ISC-C1 Rack

Title		
ISC System Wiring Diagram		
Size	Number	Revision
B	D1900511	V6
Date:	10/06/2021	Sheet of 1 38
File:	C:\Users\...ISC_C1_SH1.SchDoc	Drawn By: Filiberto Clara

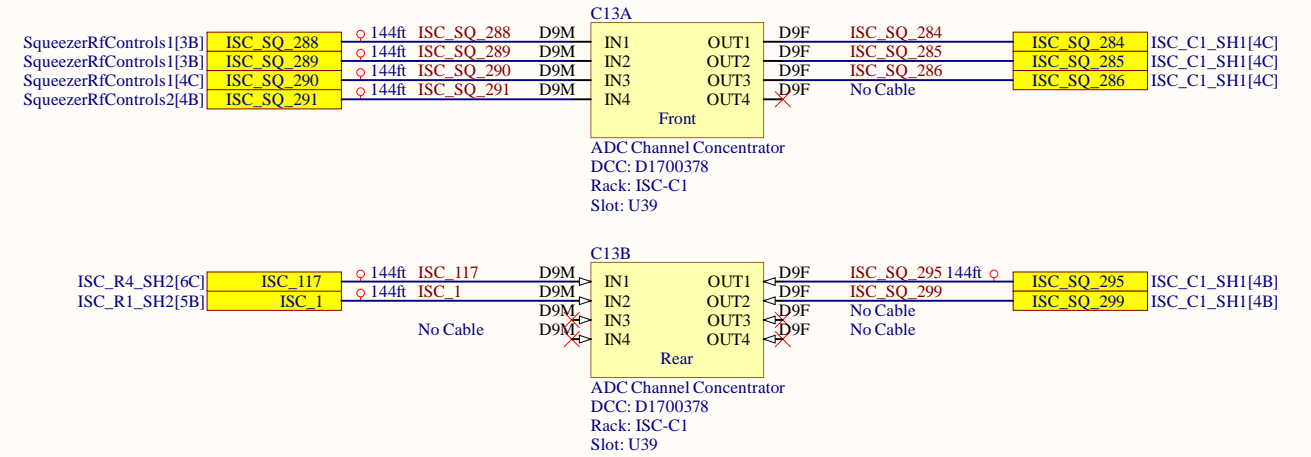
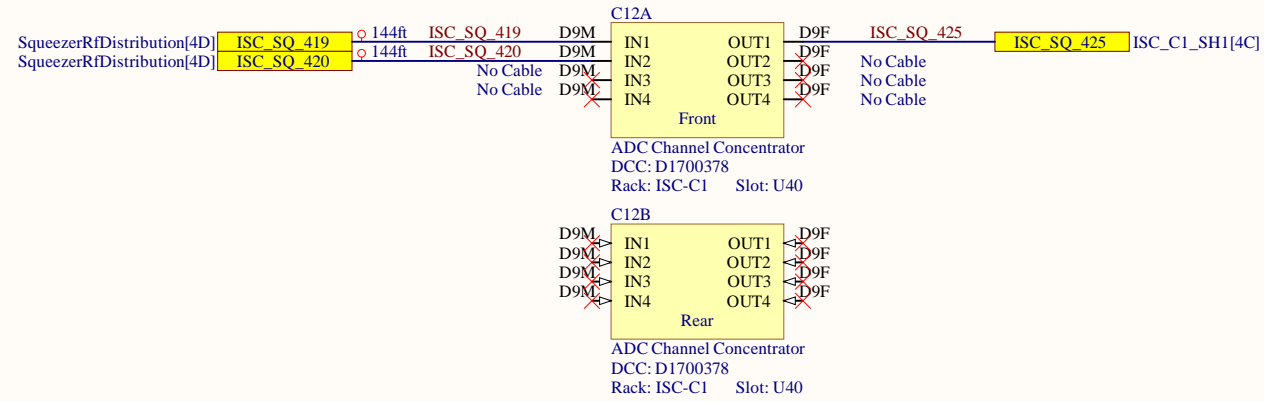
Needs Label

Reverify cables, showing ISC_426 and ISC_427 as connected in ISC-R5 rack but not in CER.

Following cables are not connected in the CER:

ISC_101, ISC_175, ISC_242, ISC_410, ISC_426, and ISC_427

ISC-C3 Rack

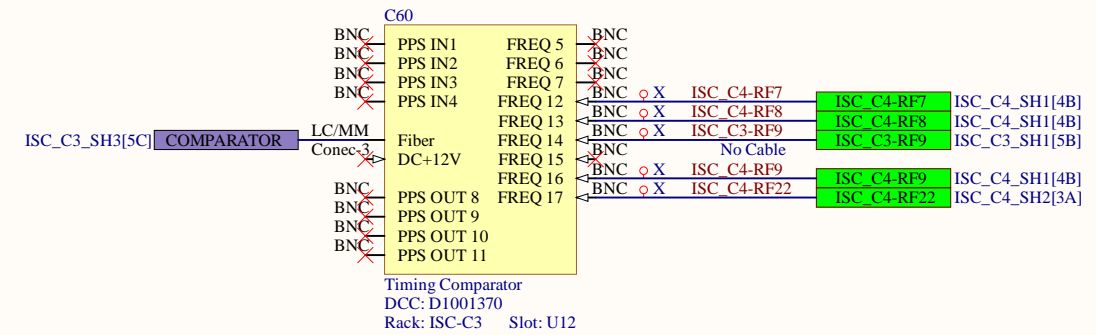
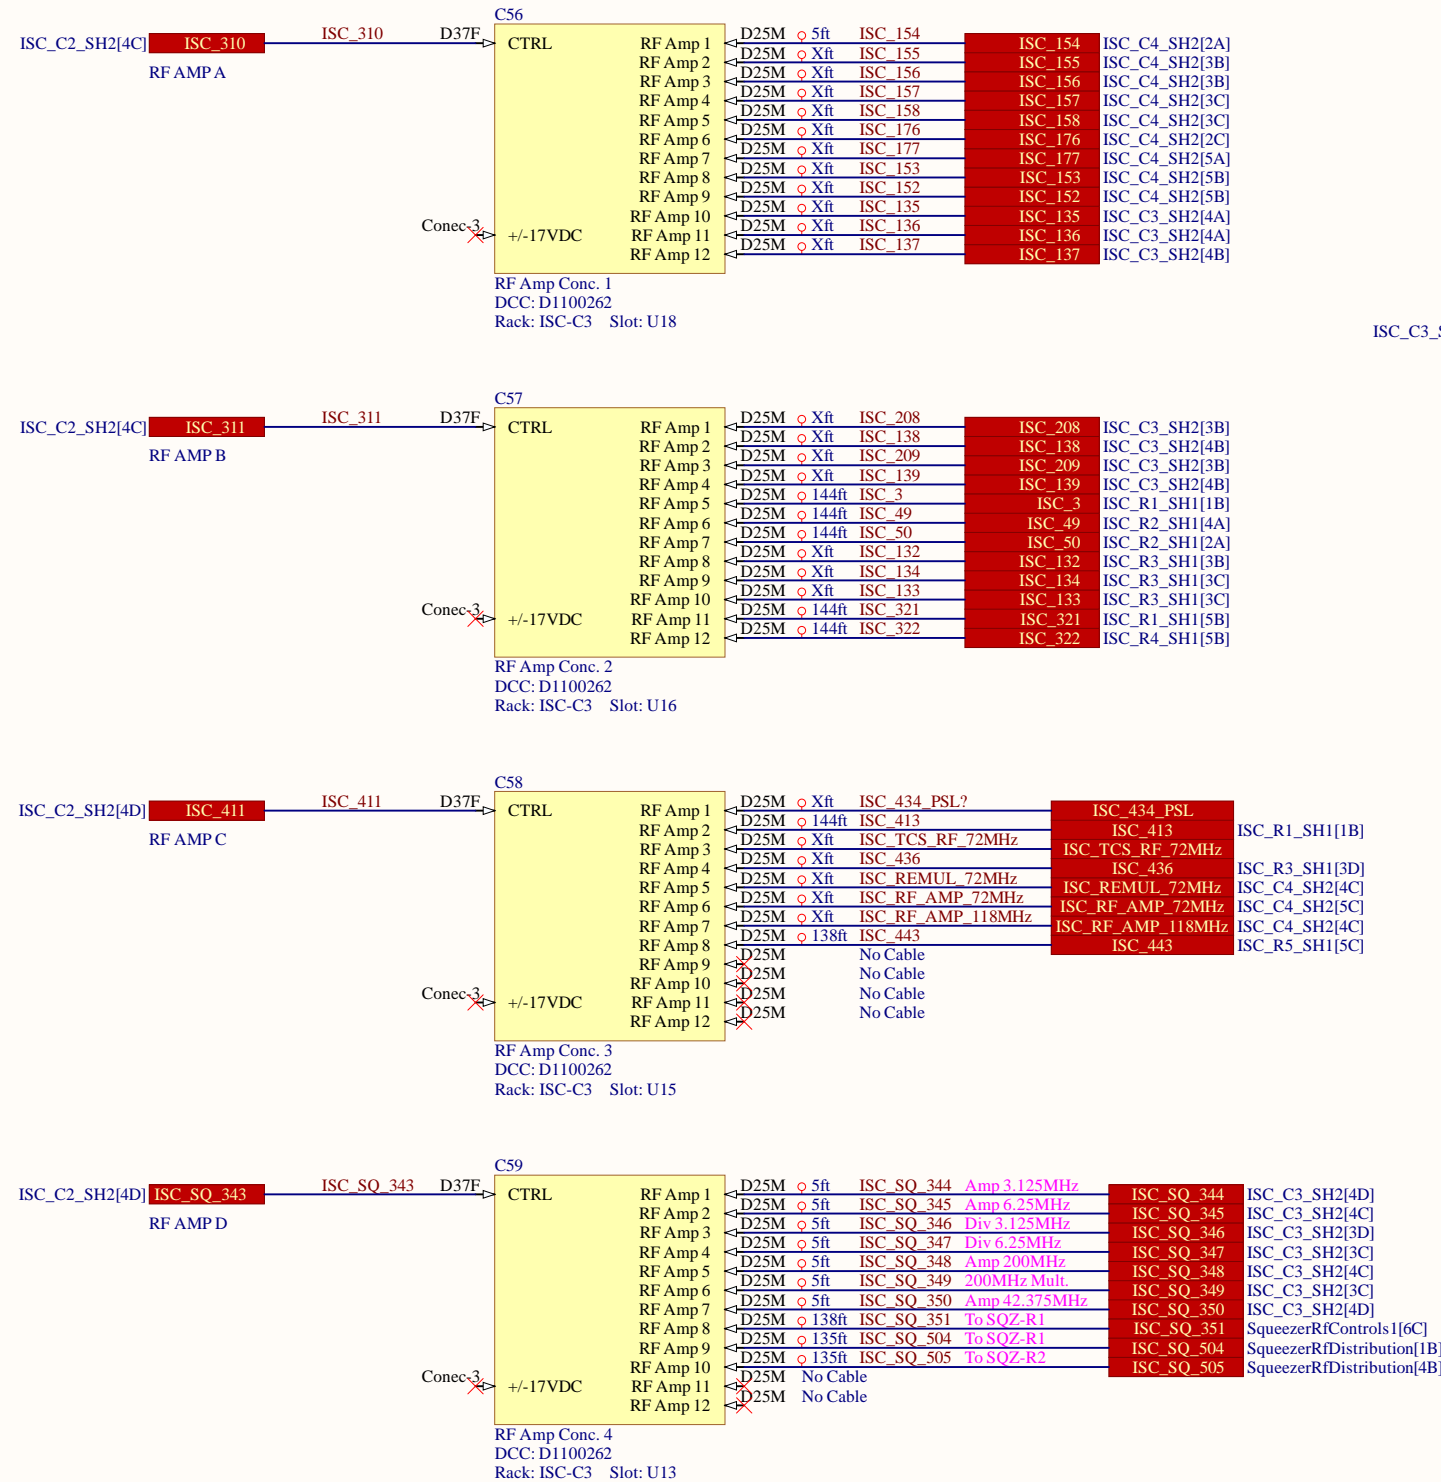
Cables that are removed
ISC_SQ_31
ISC_SQ_12
ISC_SQ_78

ISC-C3 Rack

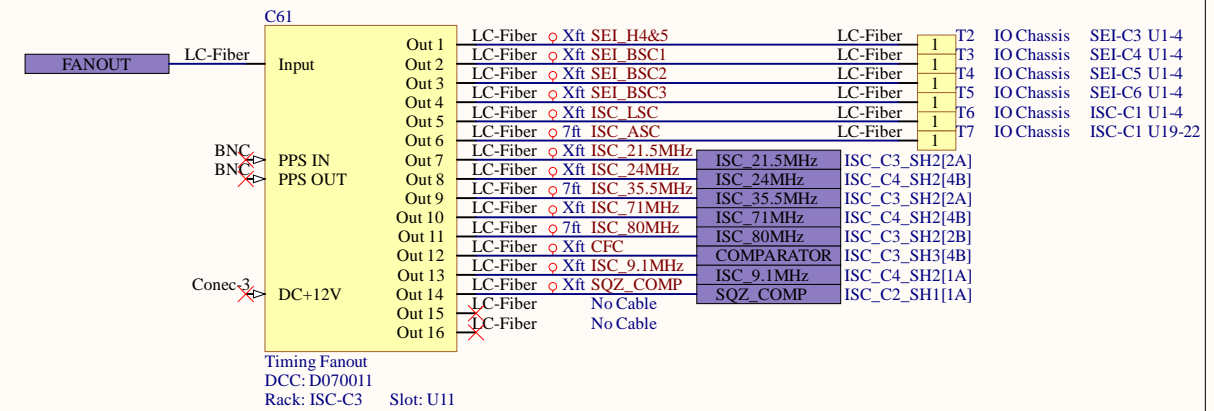
Need Locations of other ends.
 SEI IO Chassis

ISC-R1 Rack

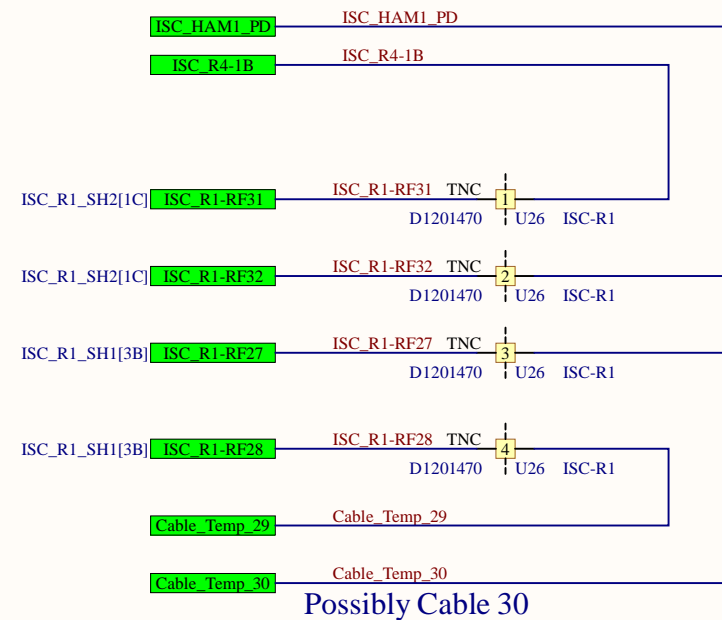
Need to label or find cable number

Recheck cables for U22
In back for PLL

ISC-R1 Rack

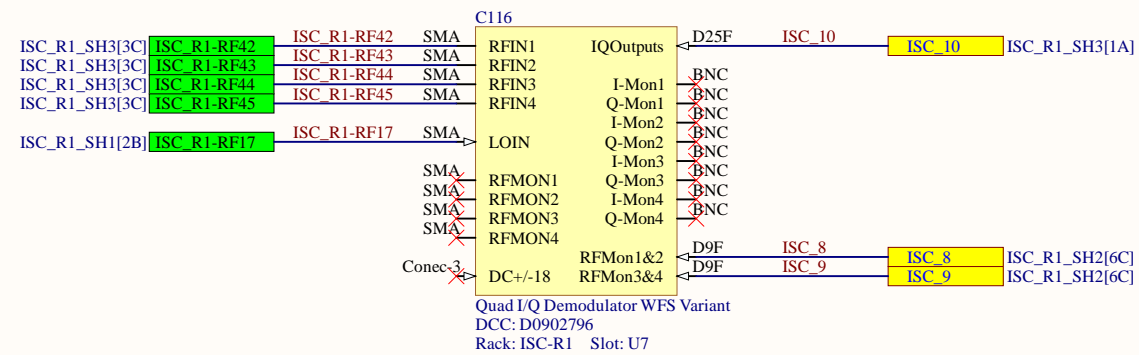
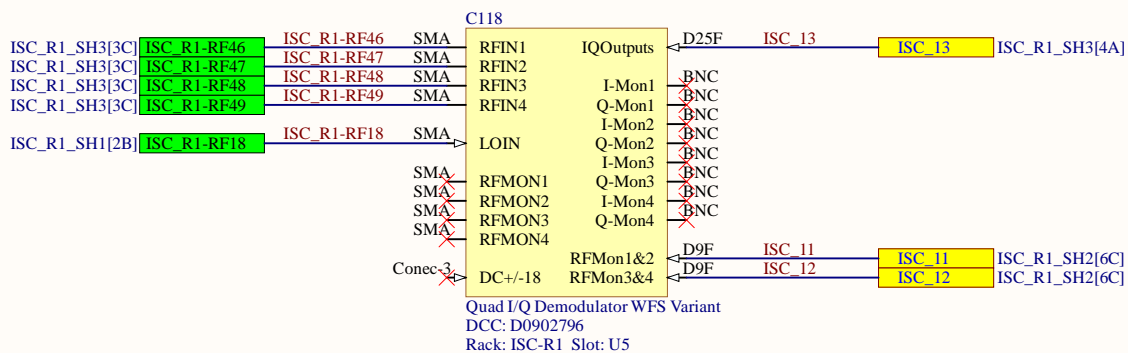
Need to locate other end

434/435 already used
 ASC-POP_X_PIT/YAW

ISC-R4 Rack

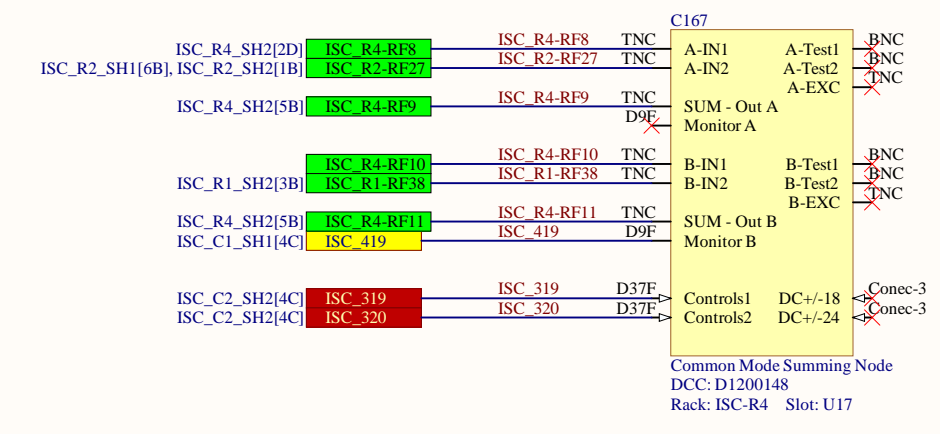
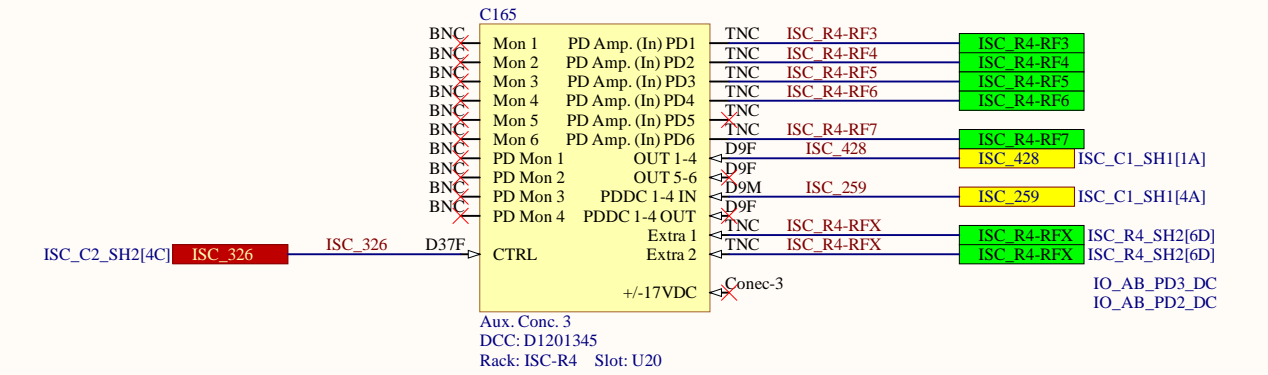
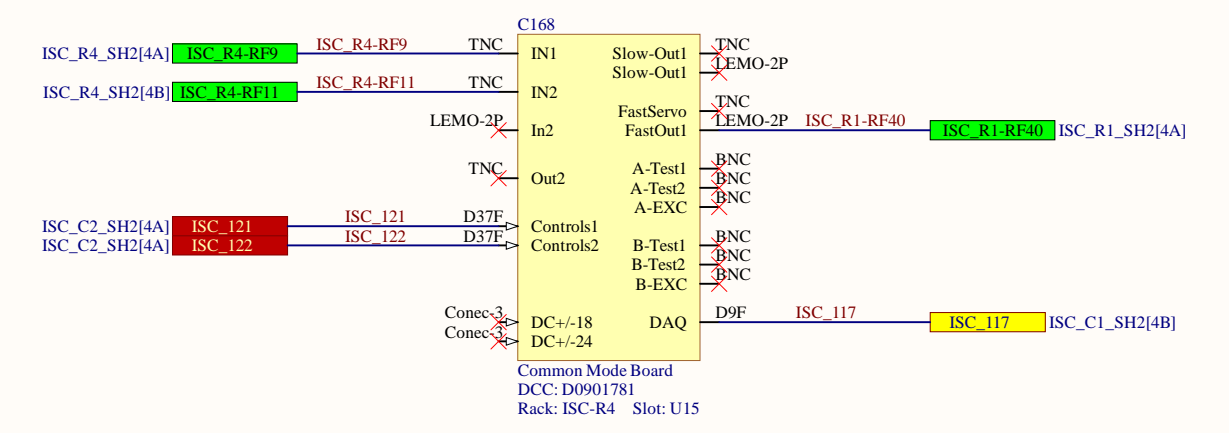
Do we need Sat Amp Included U23
 ISC_194 Coild Drive in CH1-4
 ISC_195 Coild Drive in CH5-8
 ISC_125 PD Out CH1-4
 ISC_126 PD Out CH1-4

Cable in the back.
 ISC_228
 ISC_229

Otherside not labeled. RED
 Otherside not labeled. Green
 Otherside not labeled. R4 ISC1
 Otherside not labeled. R4 ISC2
 Otherside not labeled. Old label H1_ALS_PSL_PD1

ISC-R3 Rack

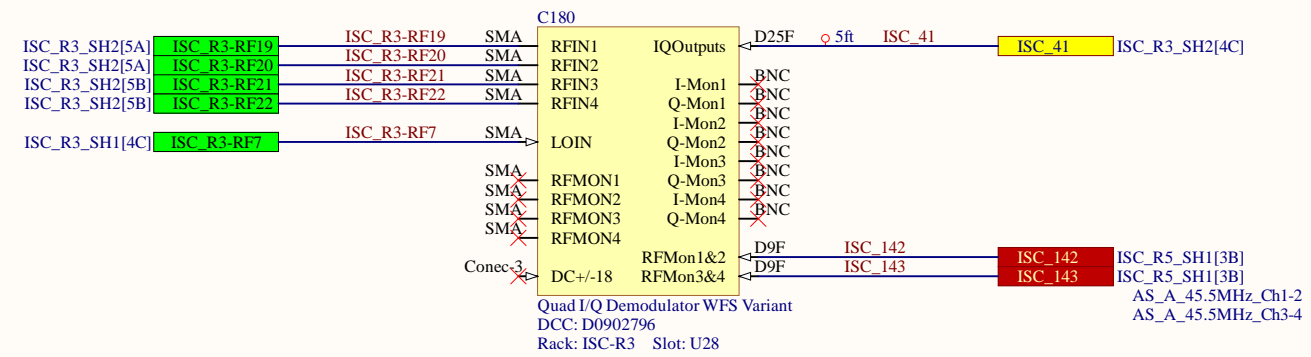
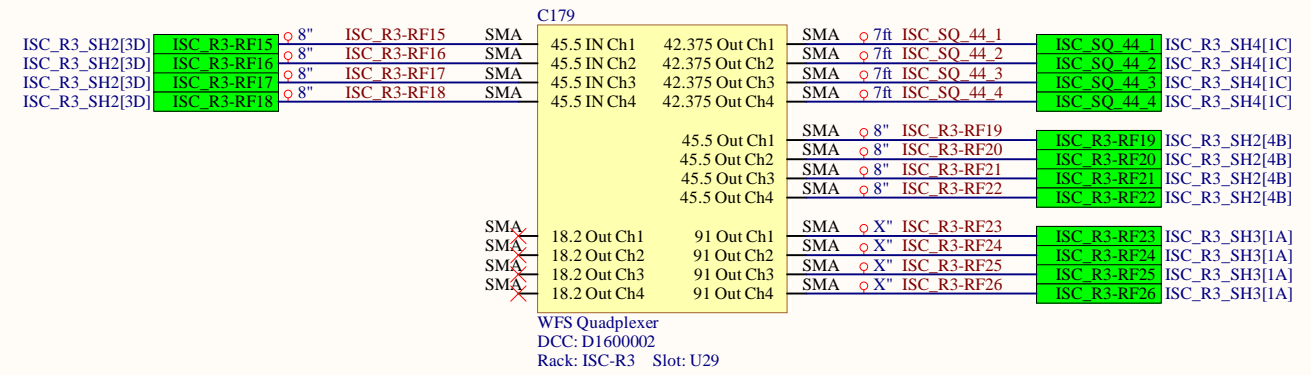
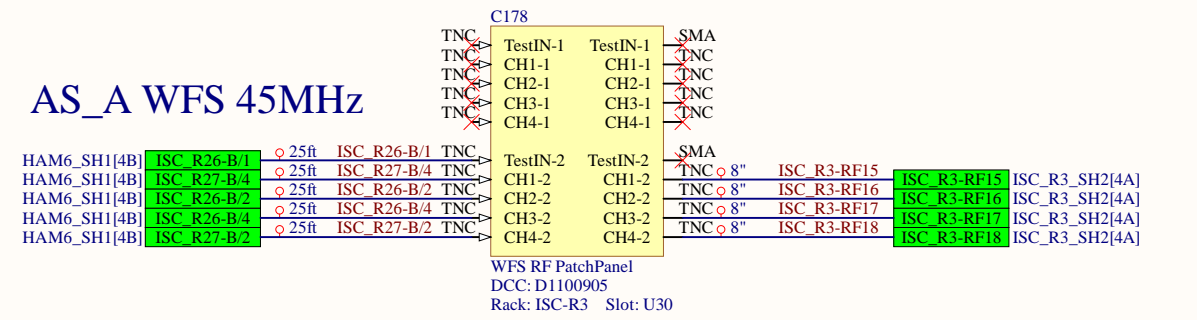
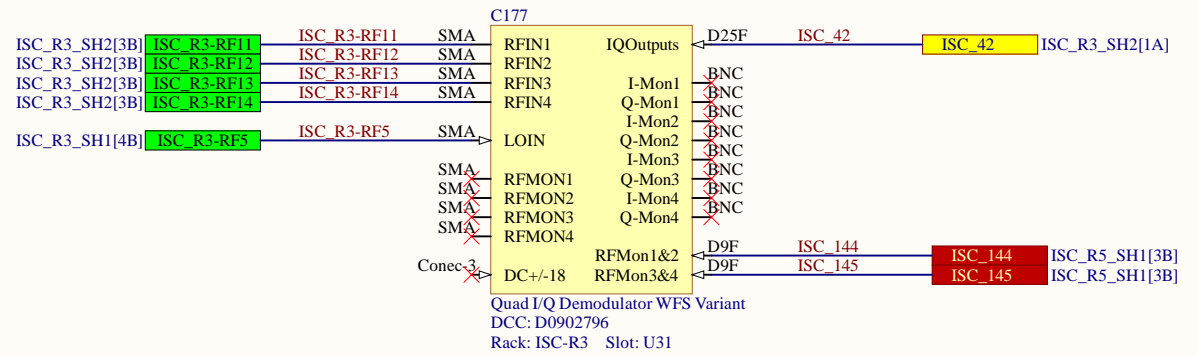
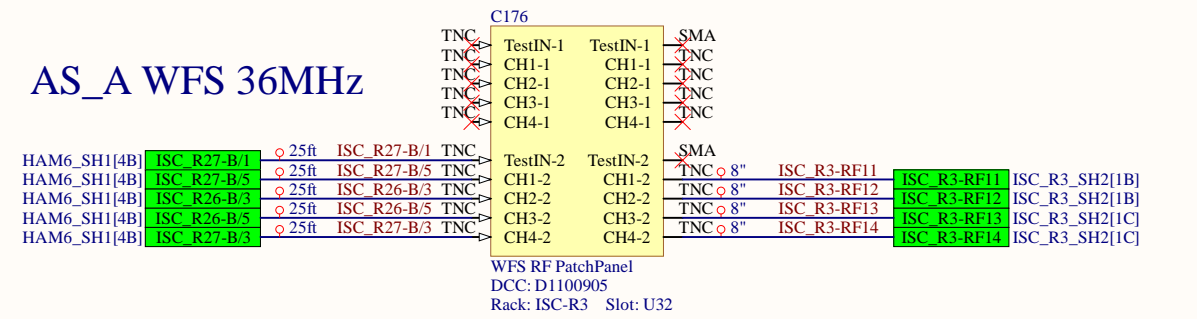
Need to Relabel ISC_R3-RF4

ISC-R3 Rack

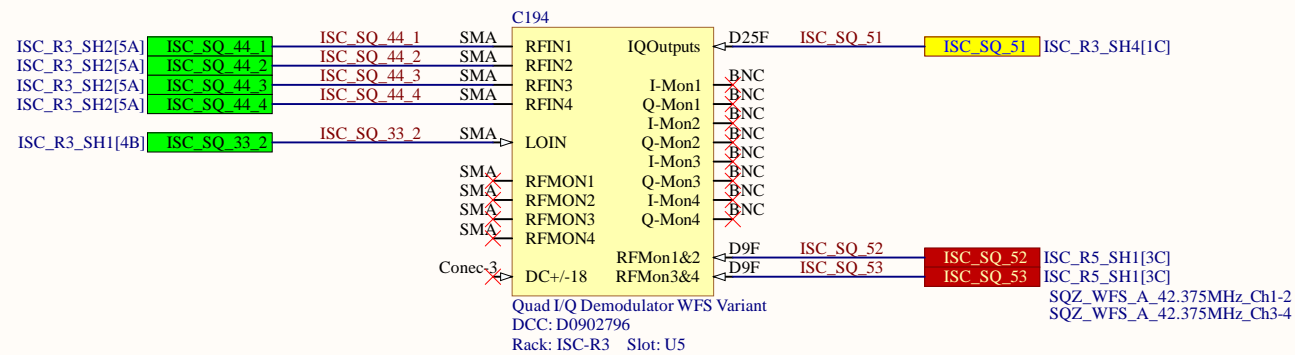
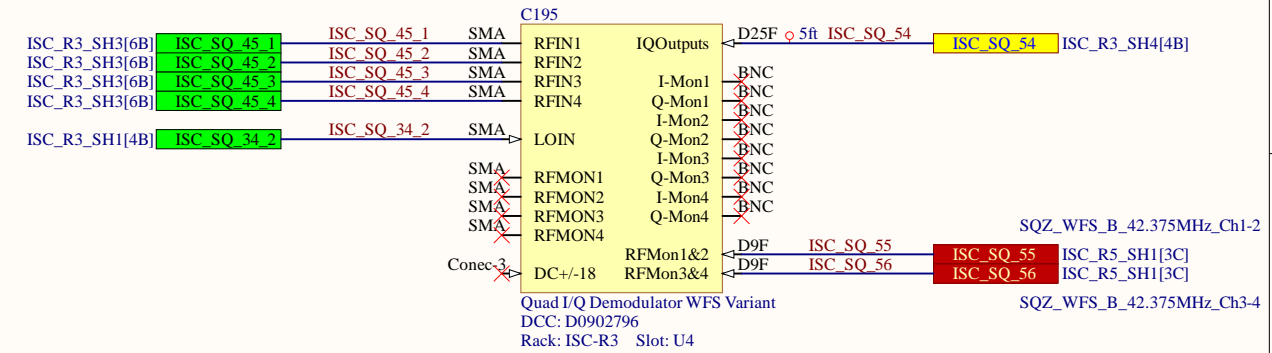
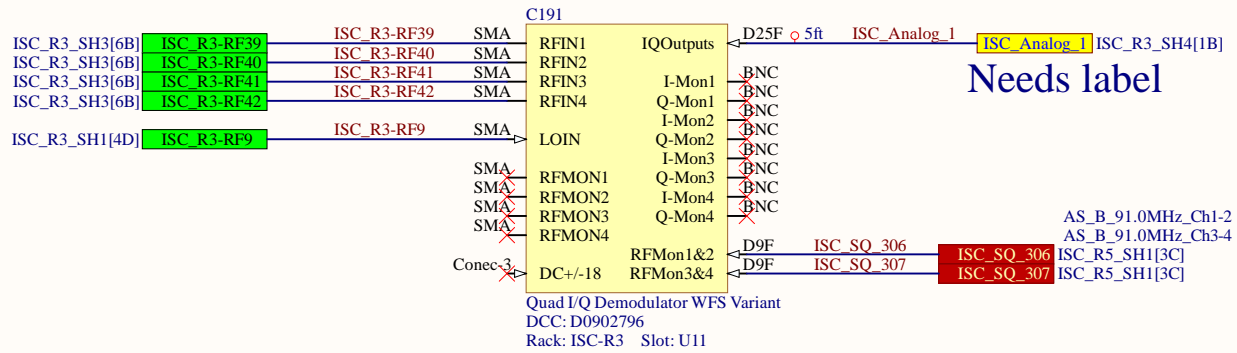
Needs labels

Needs label

HAM6 Flange Layout

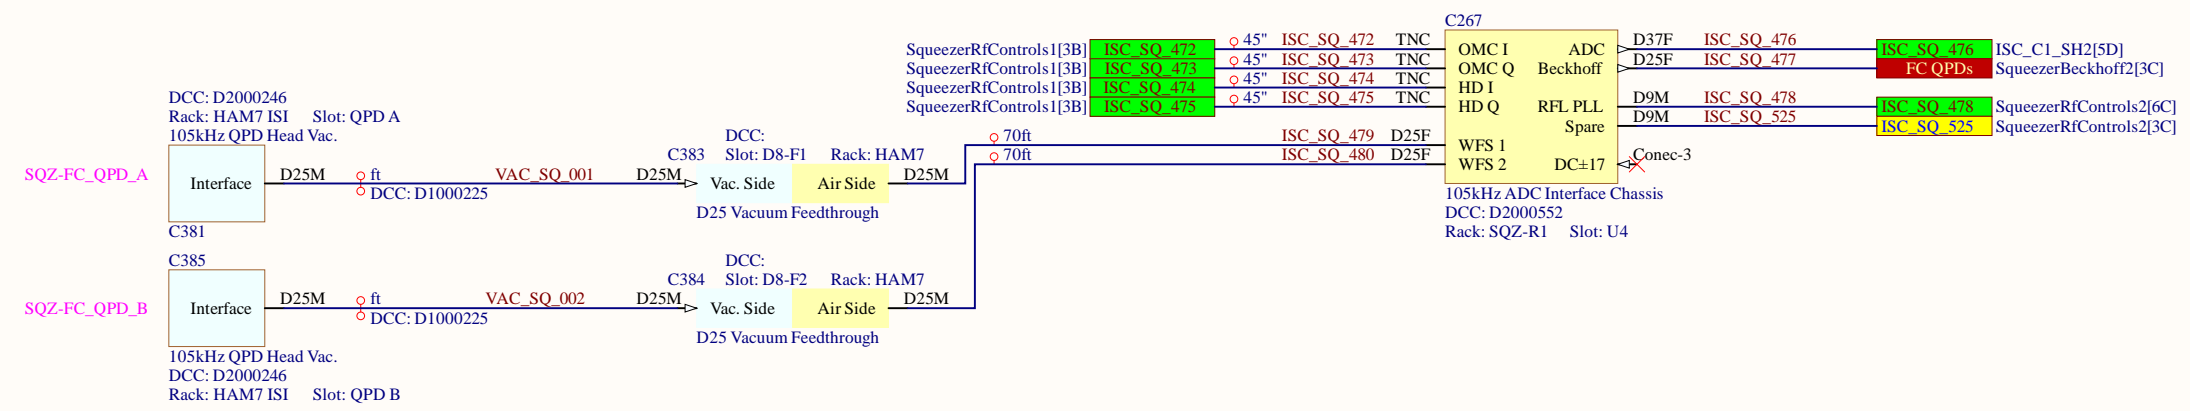
Cable ISC-235 not connected

Need to check WFS RF!
